PRELIMINARY WASTEWATER MASTER PLAN

PRELIMINARY Basis of Design SCOTTS DALE Report □ ACCEPTED ACCEPTED AS NOTED ☐ REVISE AND RESUBMIT Disclaimer: If accepted; the preliminary approval is granted under submitted for city review and approval (typically during the DR or PP case). The final report shall incorporate further water or sewer design and analysis requirements as defined in the city design standards and policy manual and address those items noted in the preliminary review comments (both separate and included herein). The final report shall be submitted and approved prior to the plan review submission. For questions or clarifications contact the Water Resources Planning and Engineering Department at 480-312-5685. DATE 9/10/2020 BY Idillon **DATE** 8/31/2020

Scottsdale Collective

Entertainment/Canal Districts Scottsdale, AZ 85251

MAYA HOTEL PRELIMINARY UTILITY EXHIBIT

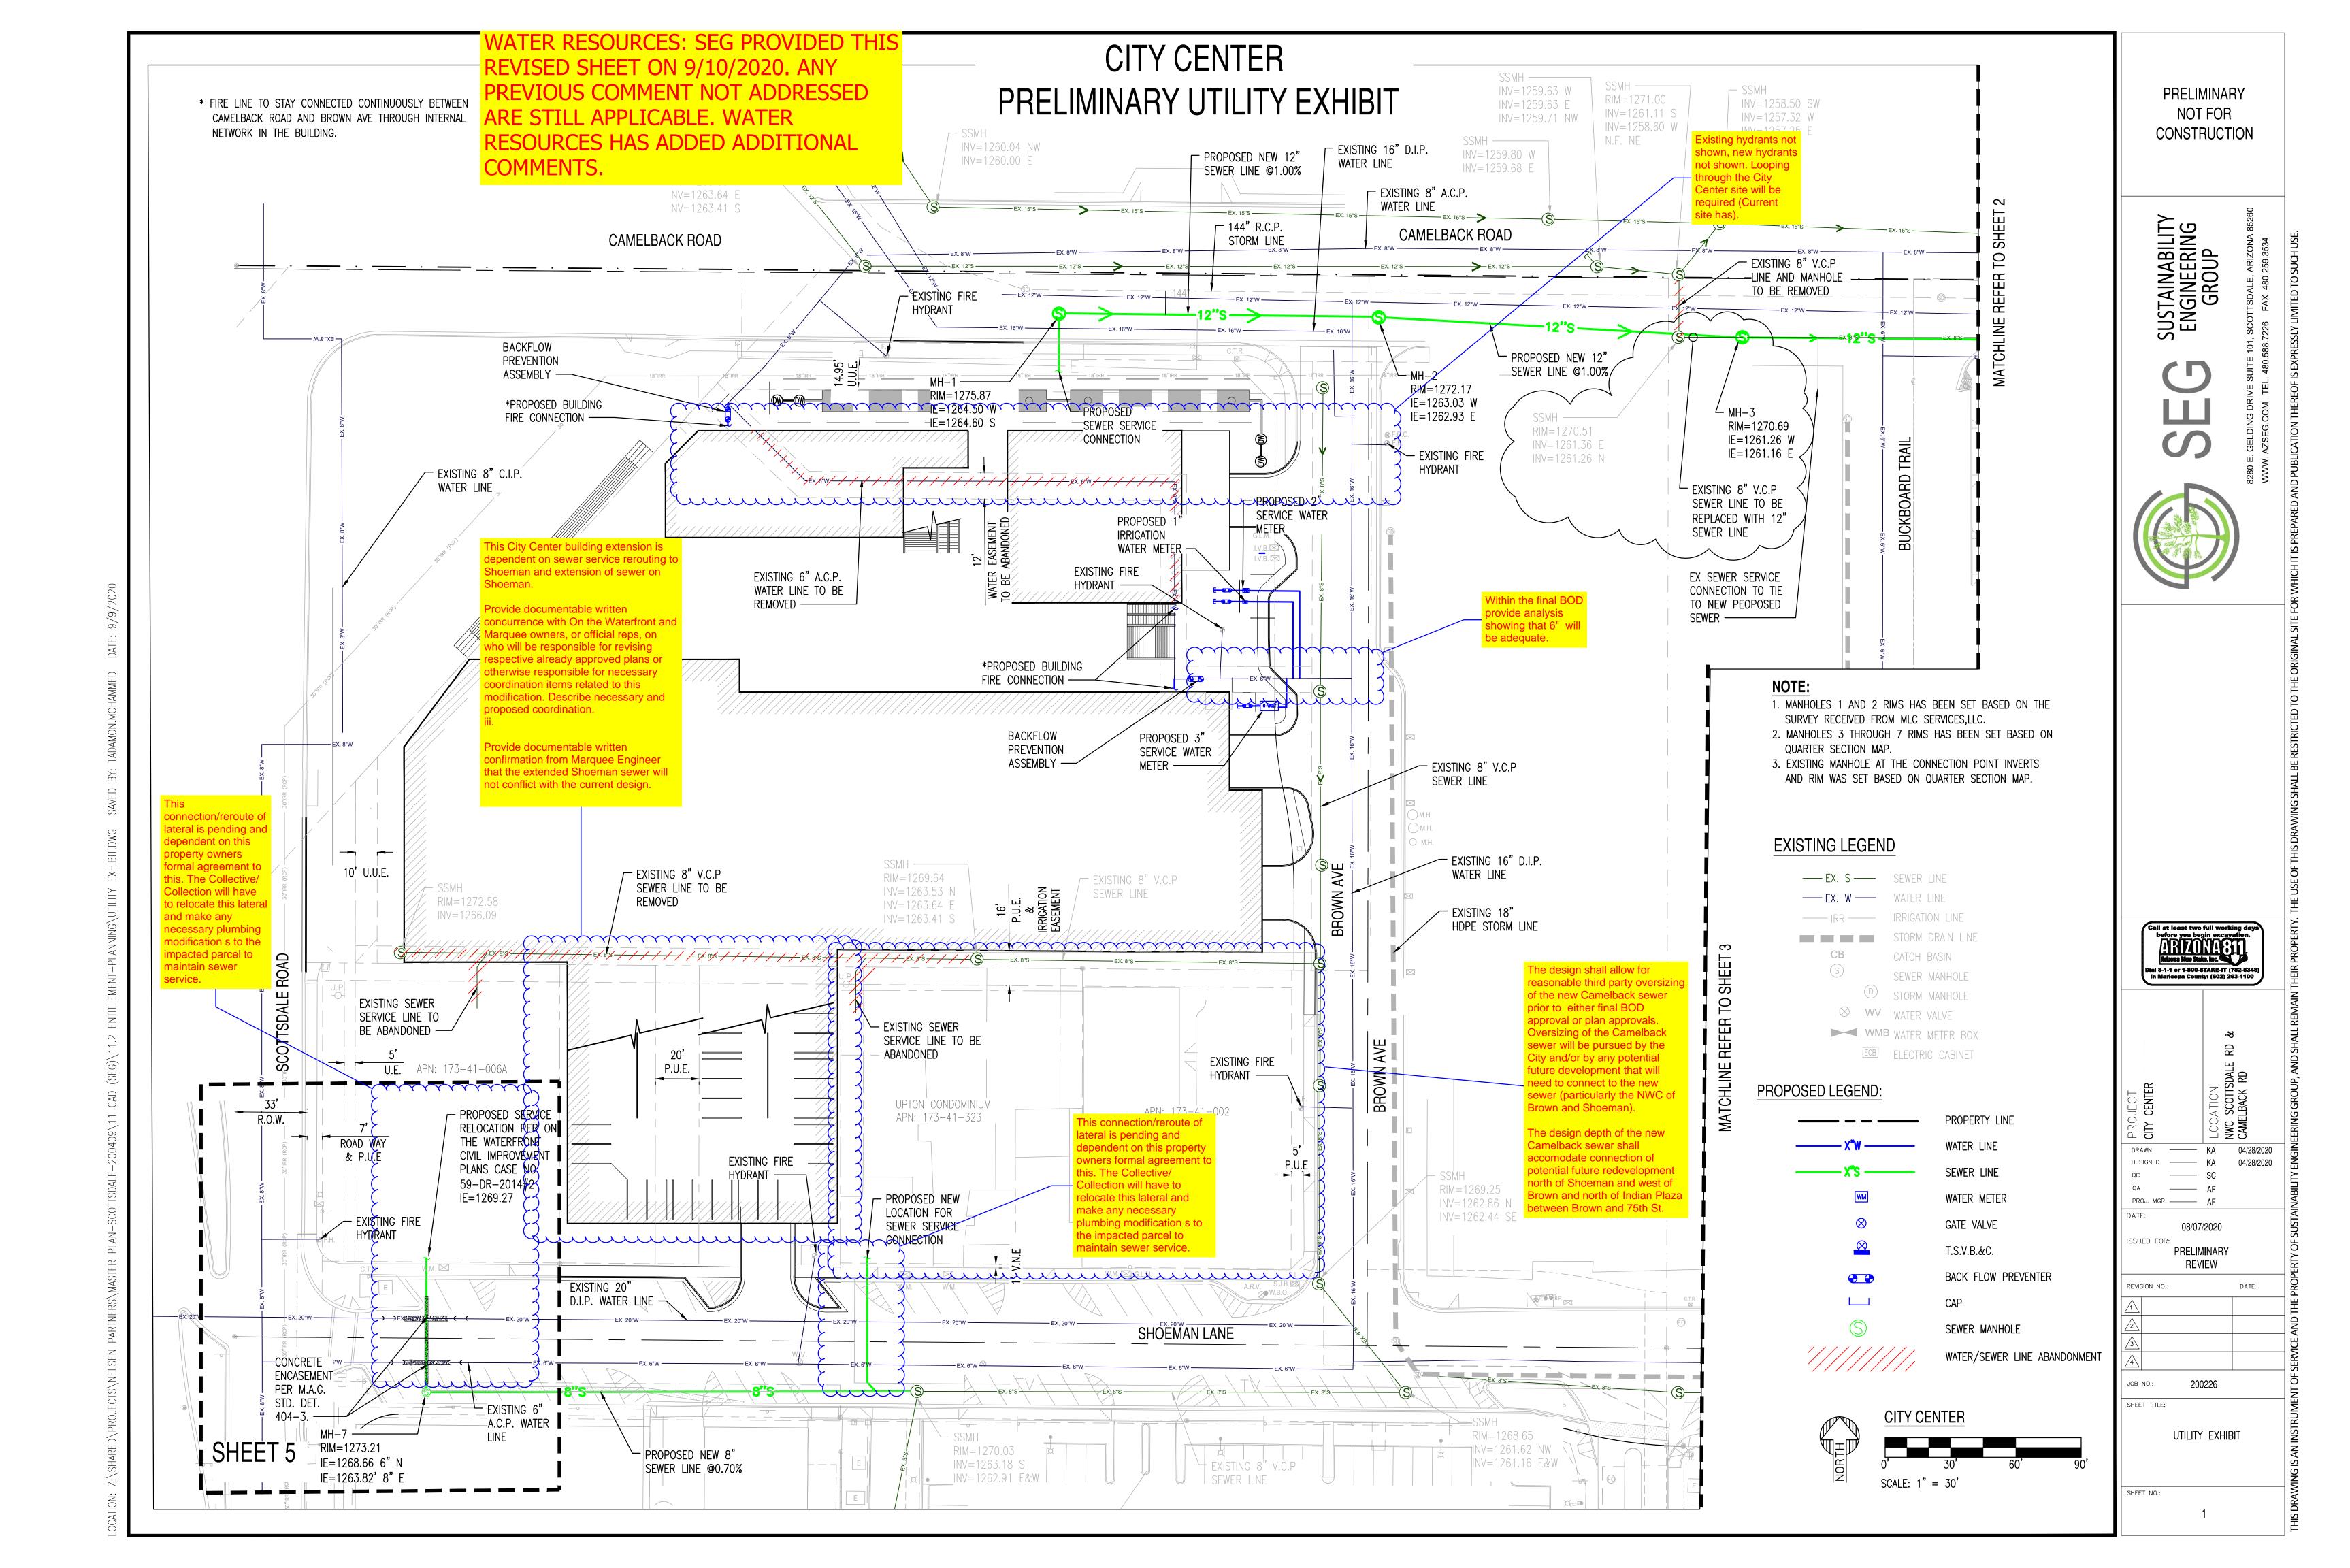
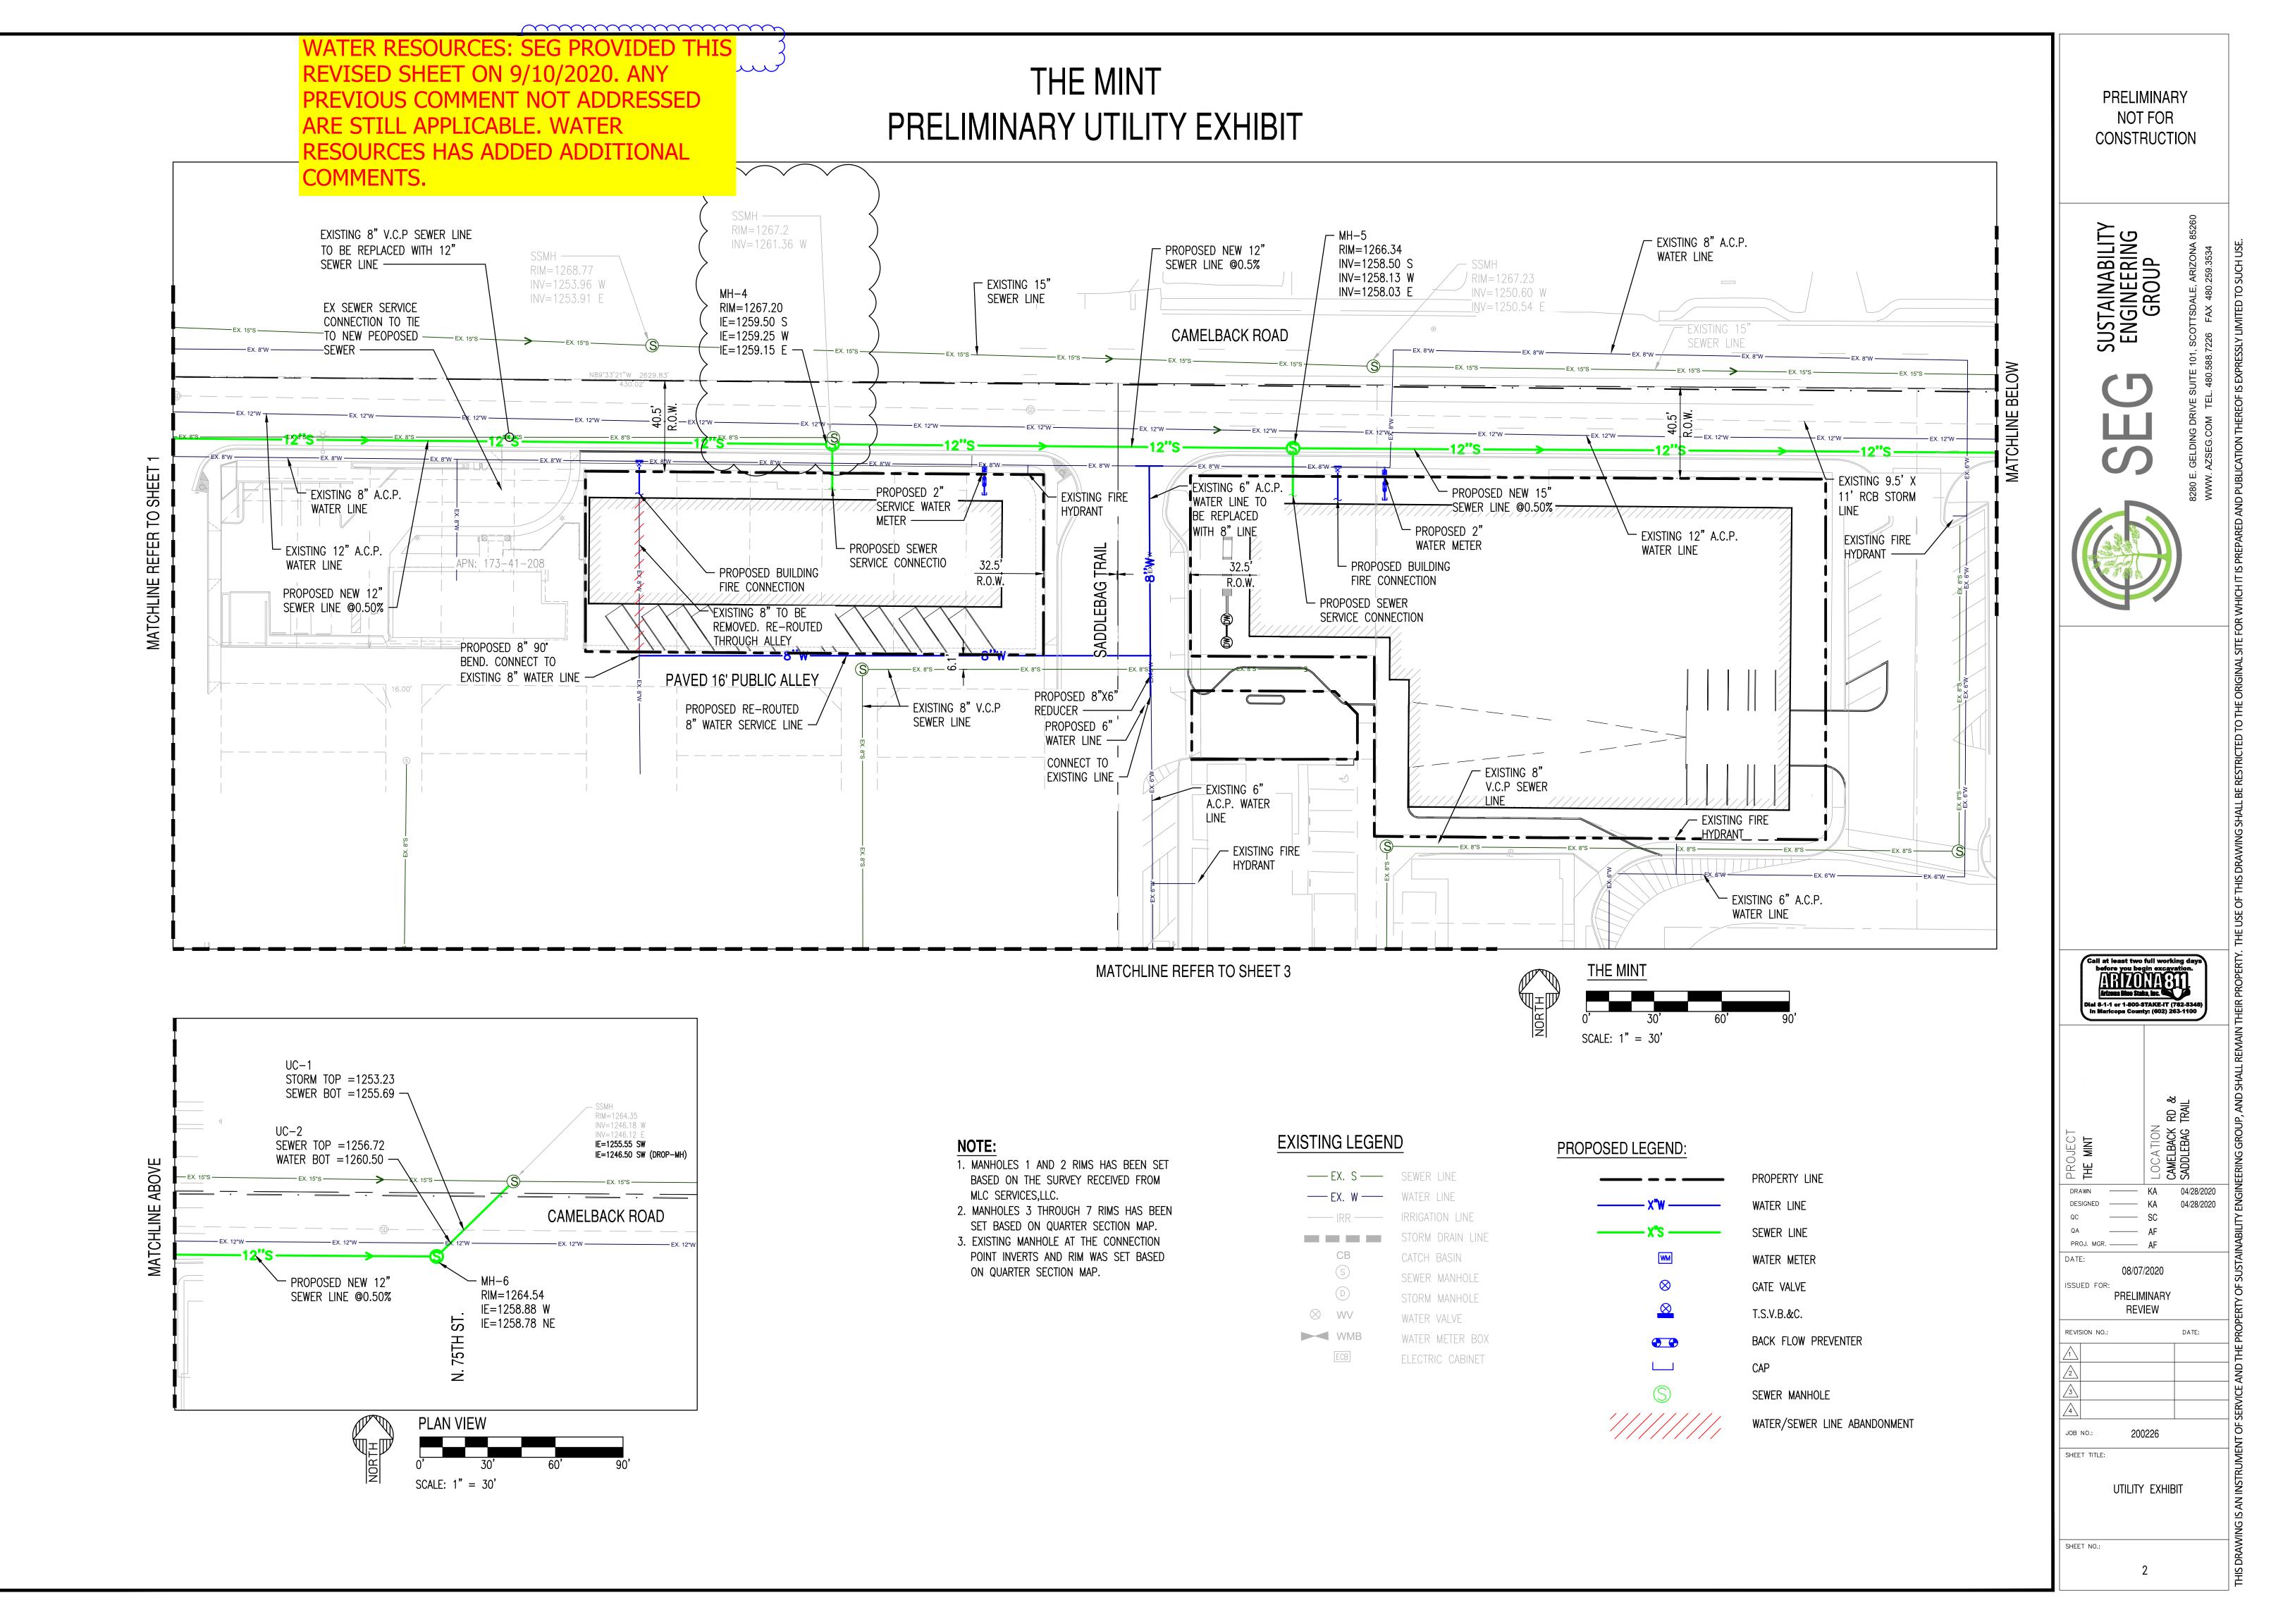
WATER RESOURCES: SEG PROVIDED THIS REVISED SHEET ON 9/10/2020. ANY PREVIOUS COMMENT NOT ADDRESSED ARE STILL APPLICABLE. WATER RESOURCES HAS ADDED ADDITIONAL COMMENTS.

PROPOSED SEWER PLAN & PROFILE

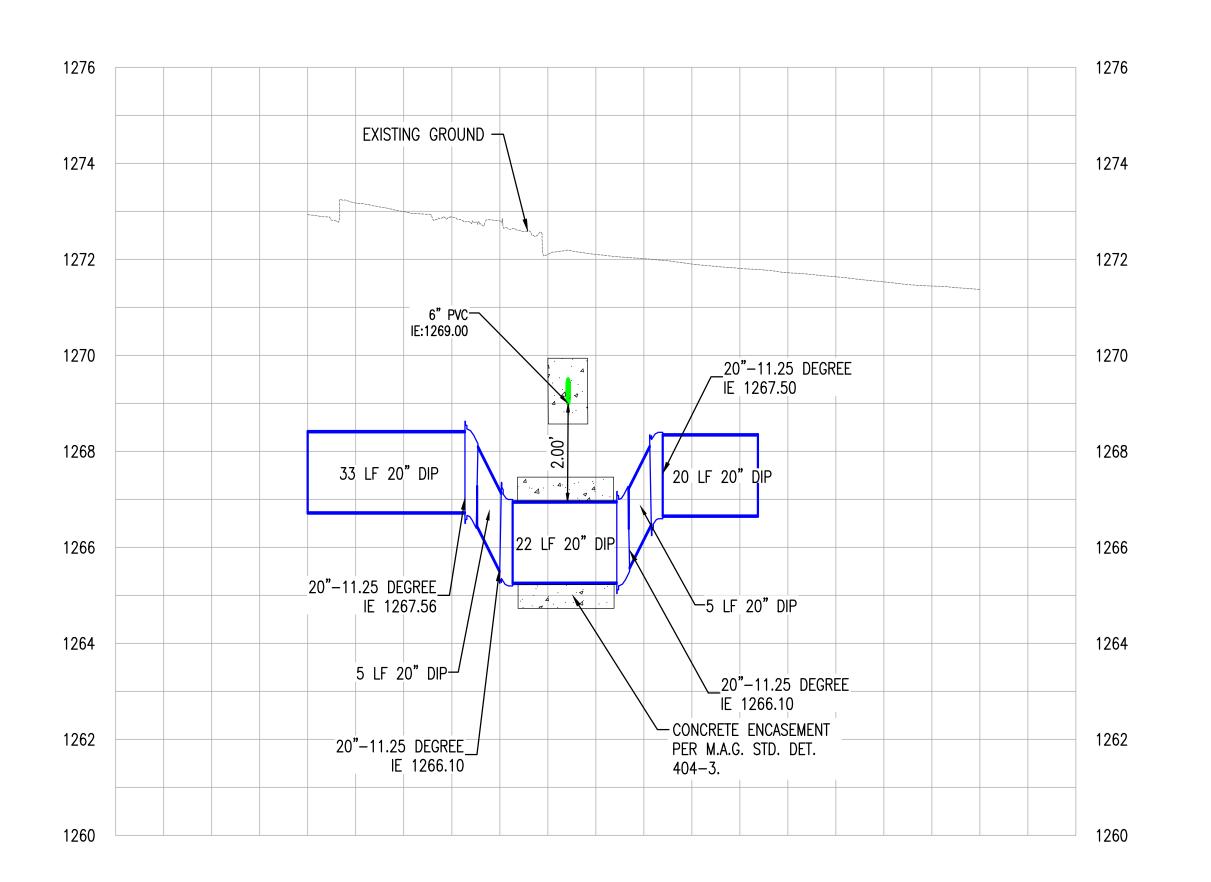
WATER RESOURCES: SEG PROVIDED THIS REVISED SHEET ON 9/10/2020. ANY PREVIOUS COMMENT NOT ADDRESSED ARE STILL APPLICABLE. WATER RESOURCES HAS ADDED ADDITIONAL COMMENTS.

NOTE:
REQUIRES VERTICAL REALIGNMENT PER MAG STD. DET.
370. PROVIDE 2' MINIMUM CLEAR SEPARATION WITH
CONCRETE ENCASEMENT PER MAG STD. DET. 404-3 &
MAG SPECIFICATION 610.5.
